## **PLANNING REVIEW CHECKLIST**

### ***Second Review Comments***

**Subject Property:** 5730 Lone Oak Road SE

**Reference Nos.:** 21-122528-LD (UGA Preliminary Declaration)  
21-122530-LD (Subdivision)  
21-122532-ZO (Class 2 Zoning Adjustment)  
21-122538 (Tree Conservation Plan)

**LOT LAYOUT PLAN**

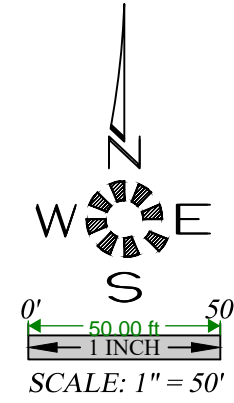
Min. 120-foot double frontage lot depth not meet. **Class 1 Adjustment** required to minimum double frontage lot depth.

Exceeds max. lot depth.  
**Class 1 Adjustment** needed to maximum lot depth.

Exceeds max. lot depth.  
**Class 2 Adjustment** needed to maximum lot depth.

Alternative Street Standard required for Red Oak Avenue

Alternative sidewalk location approval required per SRC 803.035(1)(2)(B) to allow sidewalk abutting curb.

The proposed street layout requires right-of-way to be obtained from the abutting property owner to the south for the construction of Sarah Renee Avenue. Property owner to the south is required to sign the application form since a portion of the subdivision will be their property. A property line adjustment will also be required prior to final plat approval to incorporate this portion of the property into the subdivision.

Property proposed to be rezoned to MU-II (Mixed-Use) under the Our Salem project. A future street connection bisecting the majority of the property would not be feasible for development of the mix of uses envisioned under the proposed MU-II zoning.

A future street connection to Lone Oak Road appears to be possible that doesn't split the entire property. Staff is available for further conversation and/or meetings to discuss potential feasible alternatives.

## TREE CONSERVATION N.W. QUADRANT

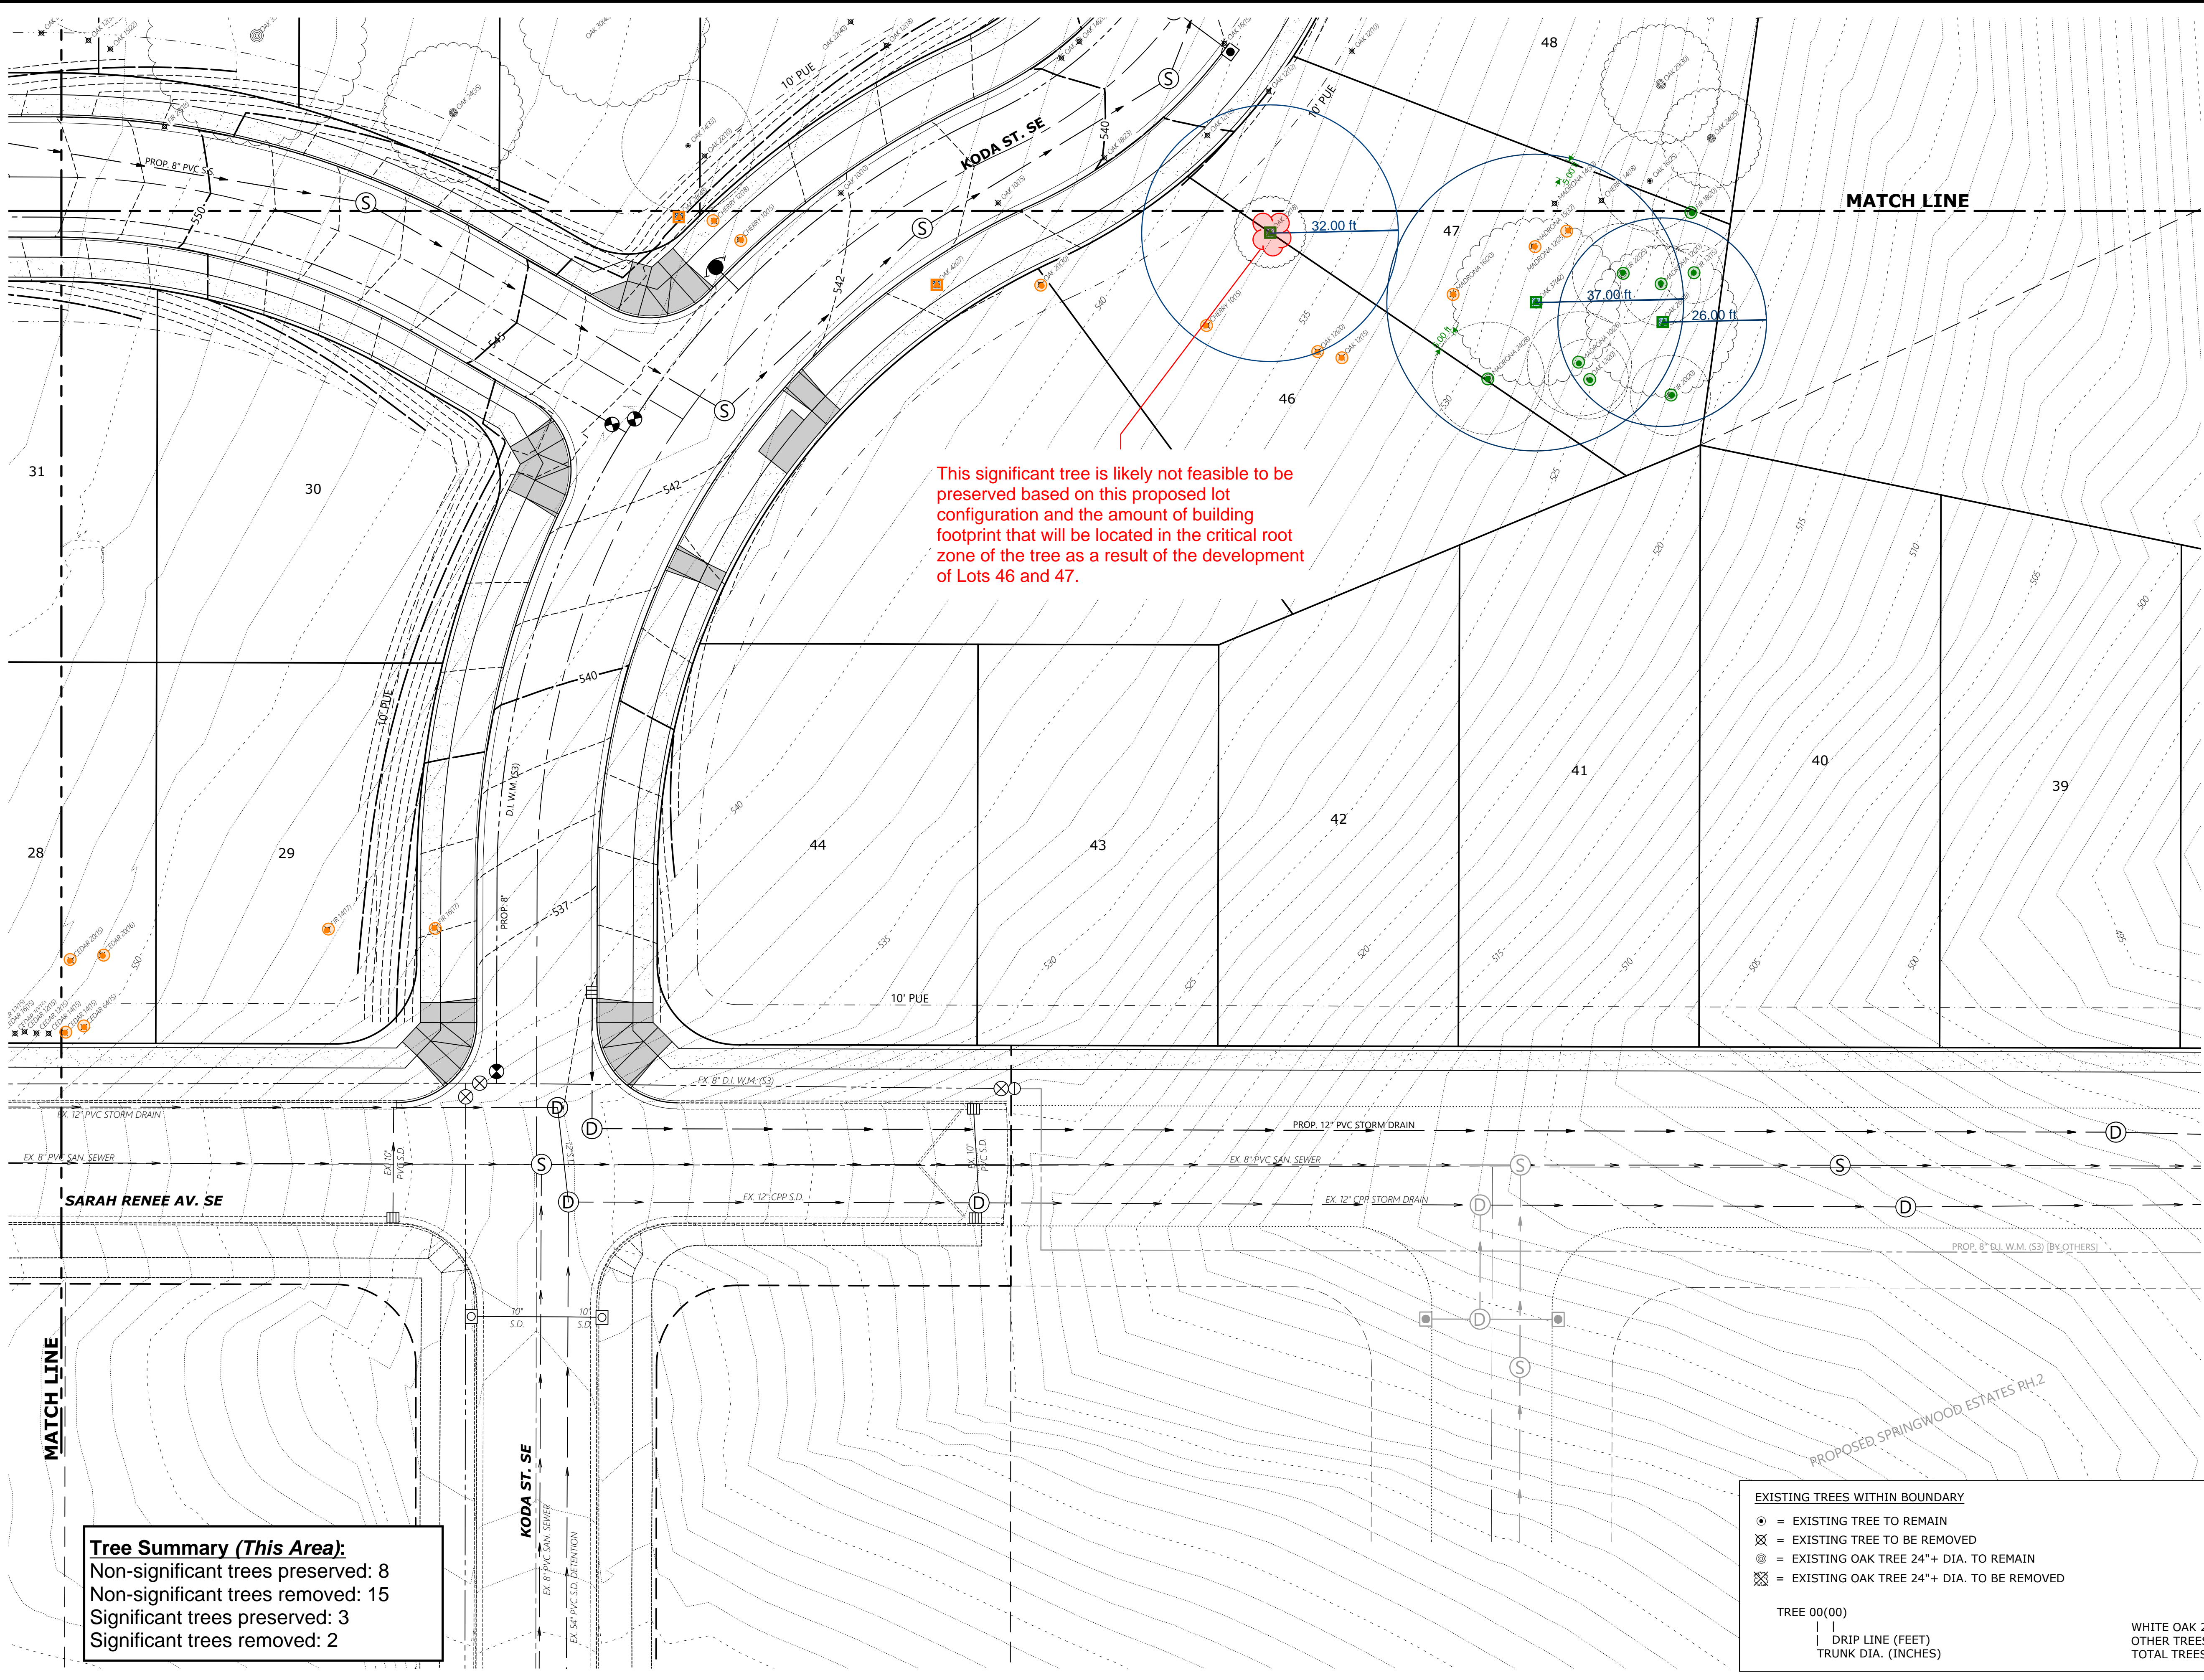
SRC 808.035 (under the old SRC 808 standards prior to the 2021 UDC update) requires a minimum of 70 percent of the critical root zone of significant trees to be protected by an above ground silt fence.

Based on the amount of grading that will be required in the critical root zone of this tree it appears that it will exceed the max. allowed 30 percent and this tree will not be able to be designated for preservation.

My count shows 107 non-significant trees for preservation. Three tree difference.

My count shows 450 total trees on site. Three tree difference.

This significant tree will be in the middle of the building envelope of the lot and is likely not feasible to be preserved based on this proposed lot configuration.

This significant tree is likely not feasible to be preserved based on this proposed lot configuration.

All of these trees are in the middle of the building envelopes of these lots and don't appear to be able to be preserved based on this proposed lot configuration.

This grouping of trees will need to be preserved. Is it possible to reconfigure the lots in this area so that future building envelopes will be outside of the critical root zones of the significant oaks?

The lots are deep. Is it planned that homes would be constructed in the rear portions of the lots outside of the critical root zones? Are all of these trees sound and healthy or are some unhealthy and compromised by the ice storm?

An explanation is needed demonstrating how these trees that are designated for preservation will be able to be preserved with the development of the lots or a reconfiguration of the lots will be needed.
